## CAIRNGORMS NATIONAL PARK AUTHORITY

**Title:** **REPORT ON CALLED-IN PLANNING APPLICATION (ADDENDUM TO ORIGINAL REPORT-PAPER 10 -11 DECEMBER 2009)**

**DEVELOPMENT PROPOSED:** **ERECTION OF 30 (AMENDED TO 25) HOUSES AND CONSTRUCTION OF ACCESS ROAD ON LAND SE OF MILLSIDE HOUSE, MILTON, AVIEMORE**

**REFERENCE:** **09/153/CP**

Figure. 4- Layout considered 11 December showing single plot accessed from Orbital path and numbers reduced to 25 units overall, blue dots indicate soakaways.

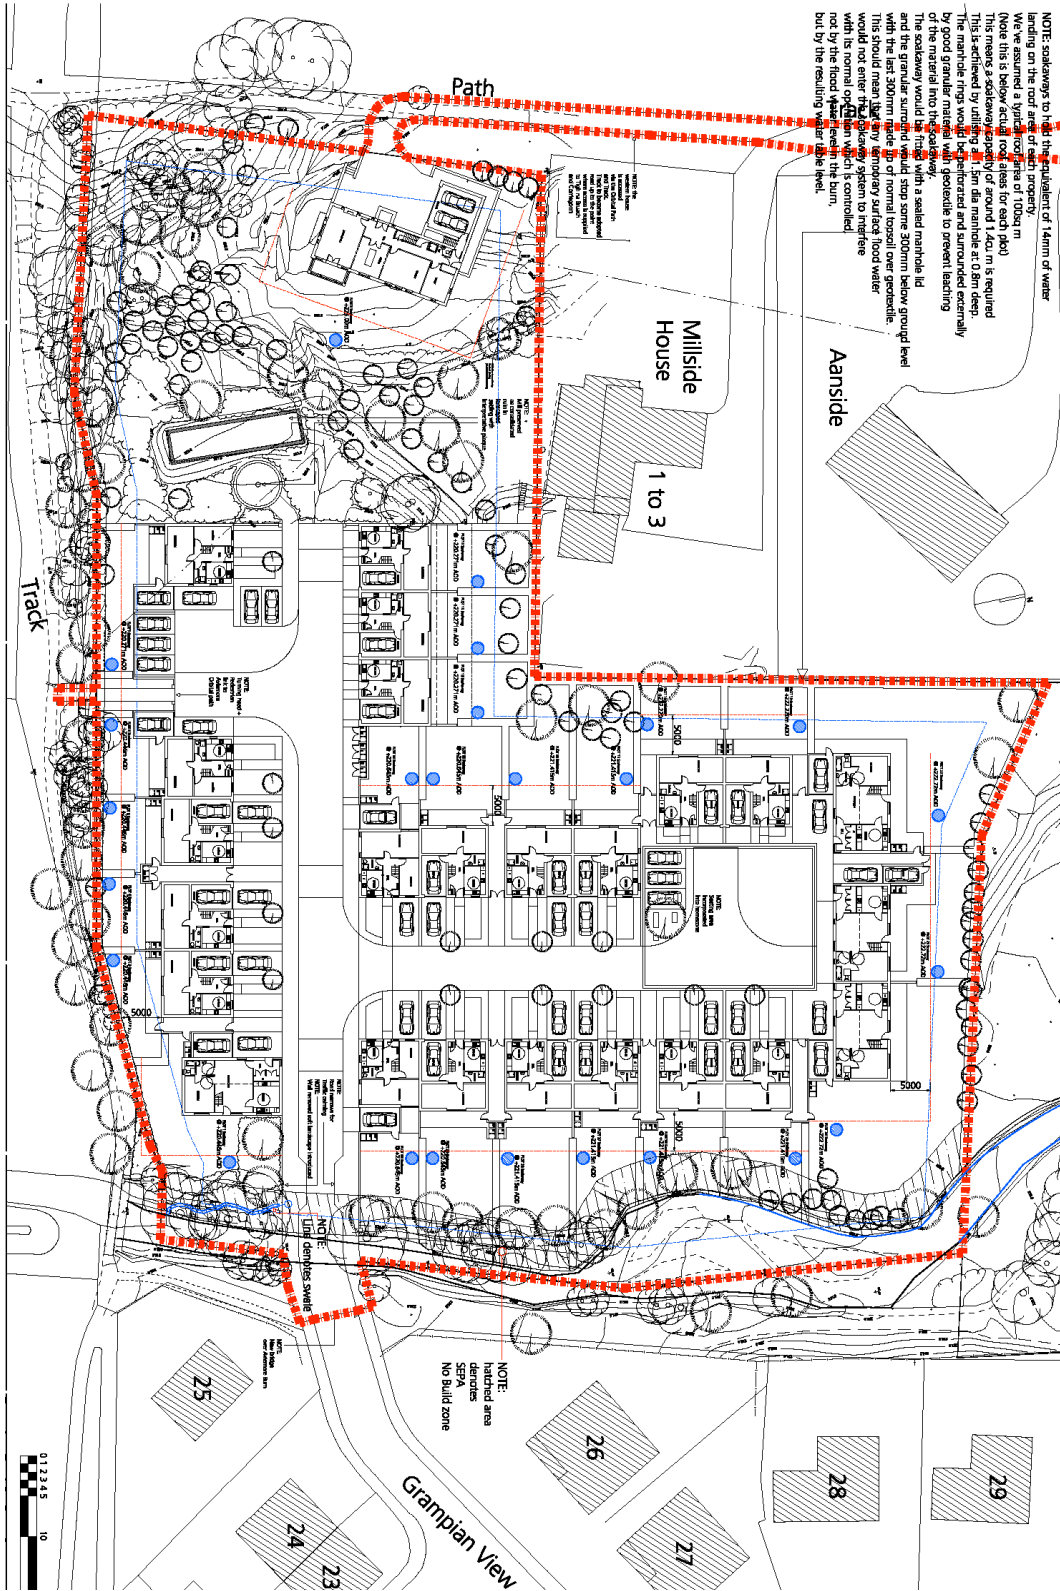
10. The site for the three plots in question consists of a steep slope with the wet area below. There are also a number of trees. While an engineered solution could, perhaps be made to work the physical effects of such a solution on this part of the site are significant. Figure 5 illustrates this where the steep contours end at the side of the house on plot 13. Overall there would have to be significant excavation and fill operations in the area of plots 11-13 making it difficult to retain any of the trees in this area.

Figure.7- Revised Layout Plan (Current).

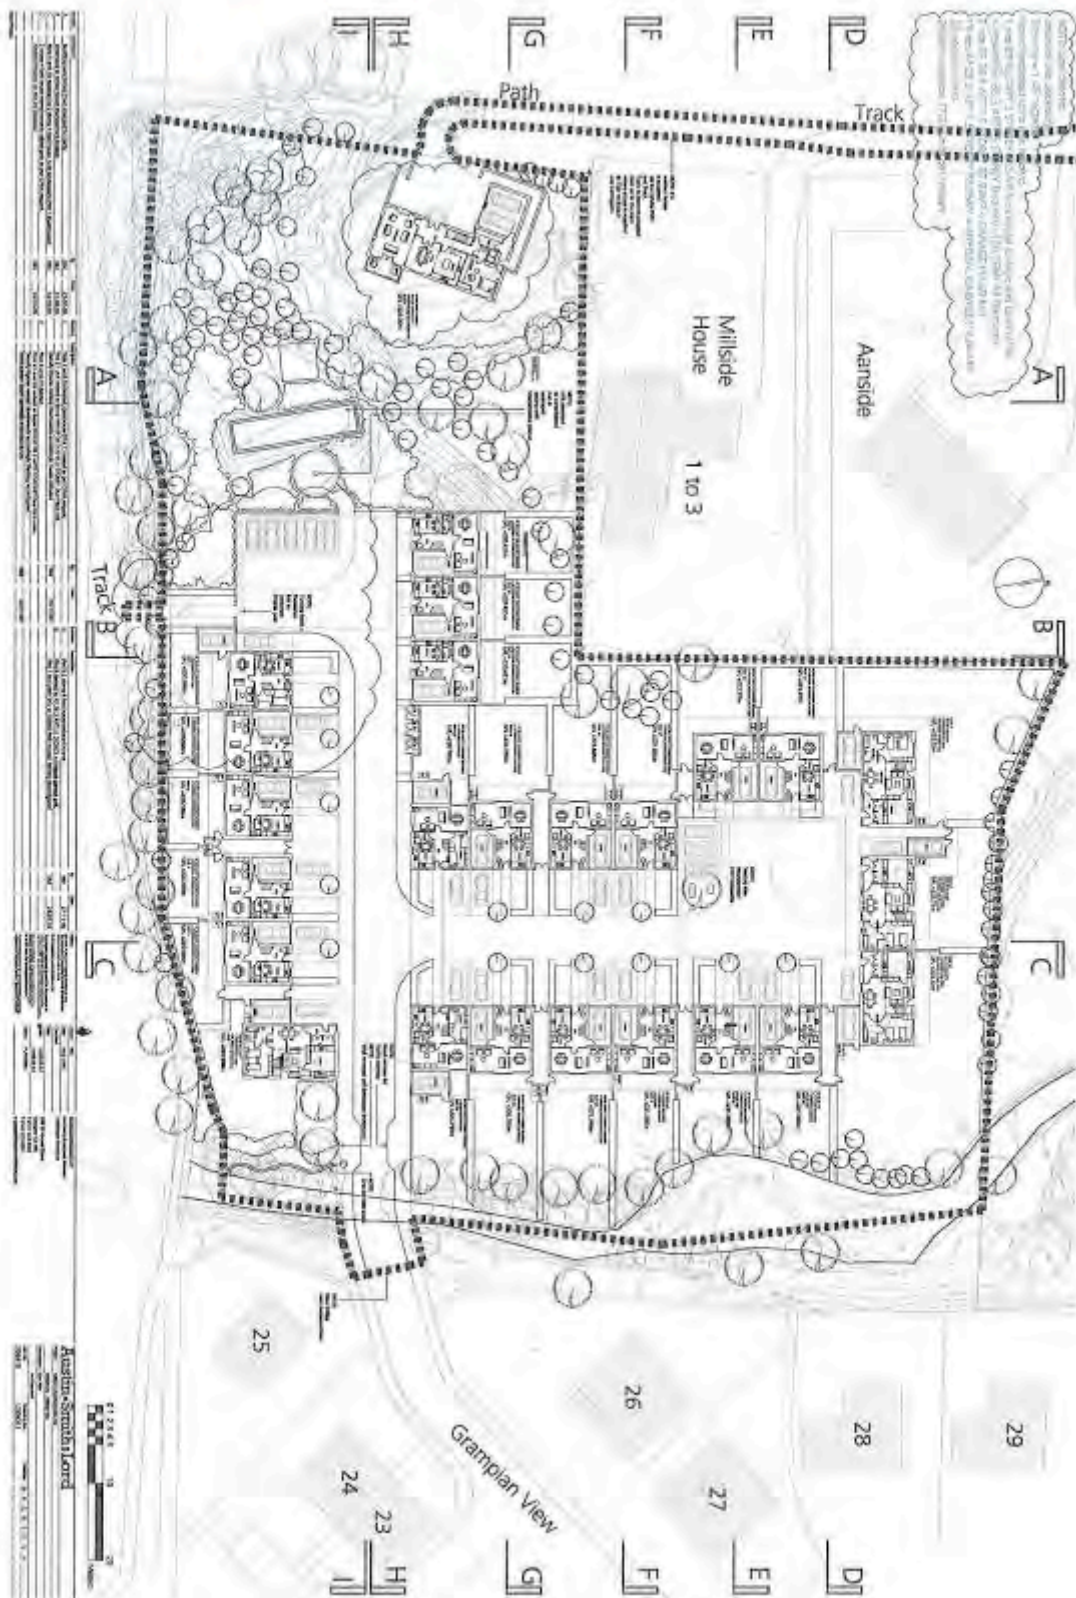
13. The applicant has submitted a revised parking strategy plan to Highland Council (Figure 6). This addresses issues raised in paragraph 50 of the original report where the isolation of plot 7 from the remainder of the development together with the parking around it raised concern that this arrangement could detract from the setting of the Mill. The parking strategy layout (figure 6) is considered an improvement upon the layout presented at figures 4 & 5. **The layout has been amended by the applicant and is now the plan for Committee's consideration and can be seen at figure 7.**
